UNITED STATES PATENT AND TRADEMARK OFFICE

10/584,802

Jon Erik Brennvall

DETAILED ACTION

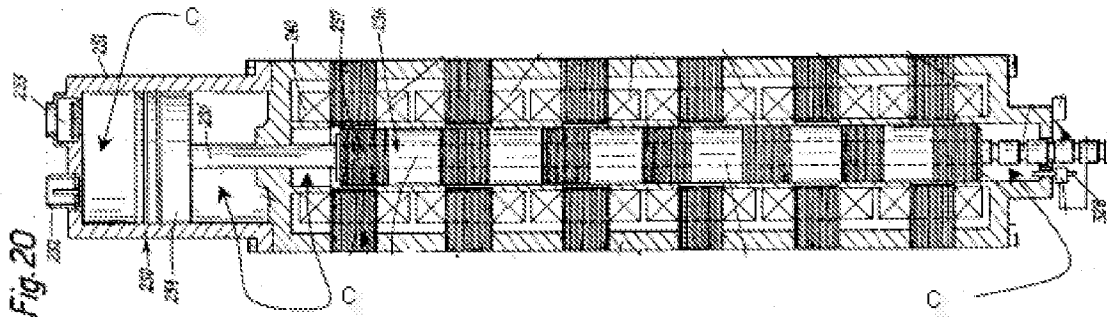
a linear movable piston (Fig 20,234) supporting a row of centrally placed tubular magnetic elements in the form of permanent magnets or coils (Fig 20,241), and arranged within the closed tubular cylinder to operate as a working element in a motor or a generator (abstract and Fig 20,231 and 325) and which is provided with magnetic elements (abstract) which establish an outwardly directed electrical field of force (Col 17 ll 58-63),

the end chambers being sufficiently tight that at each end of the piston there is formed a gas spring of high pressure providing a resonance-effective arrangement (Fig 20, C below, also Cols 3 II 63-68, C 4 II 1-5, C17 II 12-17,43-65); and

a row of tubular coordinated coils (Fig 20,240) or permanent magnets disposed around the piston (Fig 20,234) within the cylinder (Fig 20,231) for increasing piston area of the machine and/or length of stroke of the piston (Col 17 II 28-30),

interaction between magnetic fields of the coordinated coils or permanent magnets and the magnetic elements obtaining energy transmission upon axial movement of the piston in the cylinder (Fig 20 and Col 17 II 28-31).

3. Regarding claim 16, Barthalon et al teaches that the piston comprises a concentric row of tubular magnetic elements which are placed with a mutual intermediate gap (Fig 20,237,241), in which gaps are arranged tubular coil arrangements (Fig 20,240) with the coordinated coils for increasing the area of the piston.

4. Regarding claim 17, Barthalon et al teaches that the piston (Fig 20,234), is at least on one end, connected to a piston bar (Fig 20,235), said piston bar being guided out through an end chamber for transferring mechanical energy to or from the machine (Fig 20,330)

Machine according to claim 16, wherein there is a pressure inside the cylinder at each side of the piston (Fig 20,234) in the end chambers (Fig 20, A and B) over 10 bar.

(Fig 20 clearly shows that the pressure inside the piston chambers (above and below the piston) are controllable by the valves (elements 232 and 233). Barthalon does not literally teach that the pressure can be over 10 bar. Acker et al (paragraph [0064-65]) teaches that the pressure in the device can be varied up to 20 bar. It would have been obvious to a person having ordinary skills in the art to modify the device of Barthalon with the teachings of Acker et al and make a device capable of handling pressures over 10 bar. The motivation to do so would be that it would allow one to make a device intended for a particular environment or purpose by allowing one to implement active springing by means of a gaseous medium (paragraph [0010] of Acker et al.
